# Hunter-Central Coast Renewable Energy Zone Network Infrastructure Project

## **HCC REZ Reg Panel Report to the AER**

A customer's perspective in the development of Ausgrid's HCC REZ regulatory proposal

30 May 2025

*Figure 3: Comparing the HCC RNI's 132 kV solution to other structures*

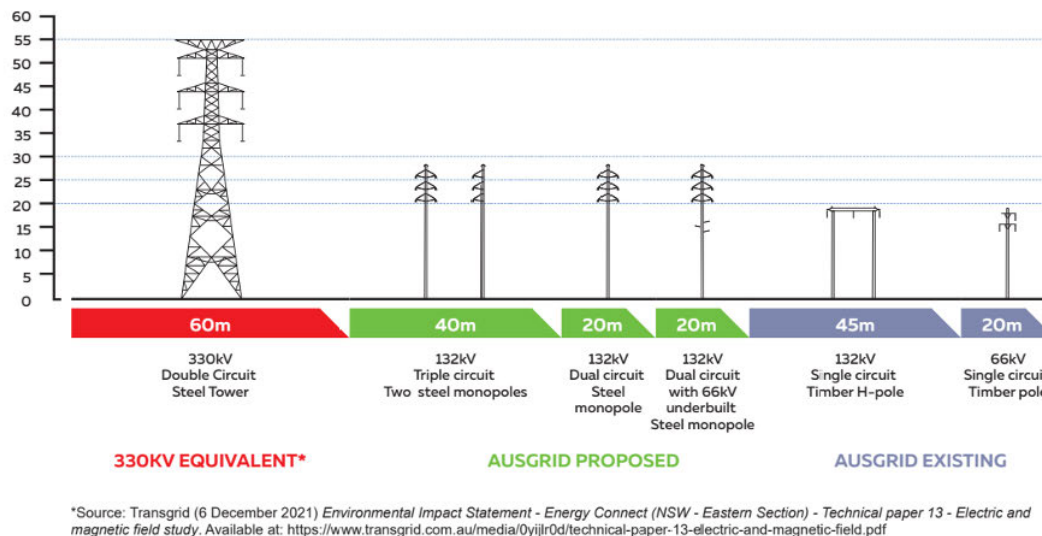
In our meeting with Ausgrid on 14 April we stressed with Ausgrid that this information may have been misleading, or at least not clearly indicative of the visual impact of the proposed development when compared to existing electricity infrastructure. (see Appendix E). Whilst we acknowledge Ausgrid's advice that the diagram's purpose is to compare the proposal with other possible solutions, this was not made clear. The issue will be that all the other towers are dull steel, flatter construction, and many are the ECNSW construction standard of single circuit on a dull, green-painted concrete pole. The new line will be very different in the number of wires that it carries, its height, and the shiny steel construction.

The Panel sent Ausgrid our feedback on this issue (see Appendix F) and in the meeting on 14 April we suggested better use of photomontages that give the community a better impression of what is proposed. We were concerned that the information provided as part of the consultation underplayed the significant change in the line landscape and could risk intervention by landholders soon after construction commenced, leading to a heightened risk of redesign and delay.

Ausgrid later confirmed that they used photomontages of the proposed line and switching stations to assist in consultation sessions with landowners in late January and early February, and in the Revenue Proposal by including Figure 5-3 below (p.45):

Figure 5-2: Ausgrid risk management process for the HCC RNI

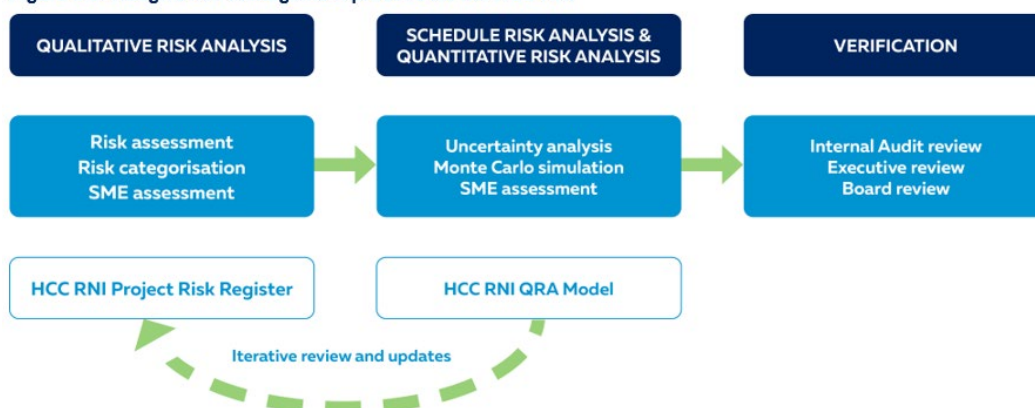
While Ausgrid was able to evaluate many risks in the course of putting its bid together, it was unable to liaise with landowners, key stakeholders and local communities until after the Commitment Deed was signed in December 2024. These risks are less developed.

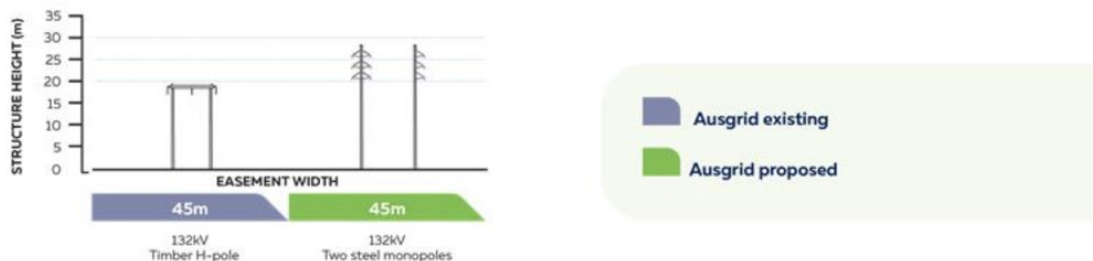
The new pole line is the predominant concern.
